**PLANNING COMMISSION PUBLIC HEARING  
ELECTRONIC MEETING**

- 1) File No: SP 21-04 & SIGN 21-03, Palm Harbor Homes

TO: Matt Straite, Planner  
FROM: Lora Ratcliff, Fire Marshal  
DATE: September 27, 2021  
SUBJECT: SP-21-04 – Palm Harbor Home Sales – Fire Department Comments

TO: Matt Straite, City Planner  
FROM: Janelle Booth, Millersburg City Engineer  
DATE: October 6, 2021  
SUBJECT: SP 21-04 – Palm Harbor Engineering Comments

FIGURE D103.1  
DEAD-END FIRE APPARATUS ACCESS ROAD TURNAROUND

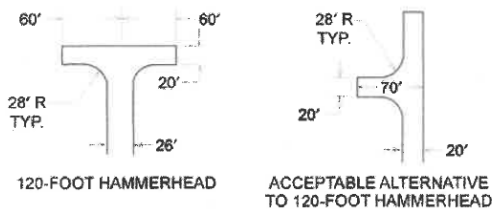
1. Approved fire apparatus roadways must extend to within 150 feet of all exterior portions of any structure that will be built on the property as measured by an approved route of travel around the exterior of the structure. (OFC 503.1.1)
2. Dead-end fire apparatus roads in excess of 150 feet in length shall be provided with an approved area for turning around fire apparatus (OFC 503.2.5 and D103.4)

**A turnaround is required due to the length of the access road. Future plans shall indicate where the turnaround will be located.**
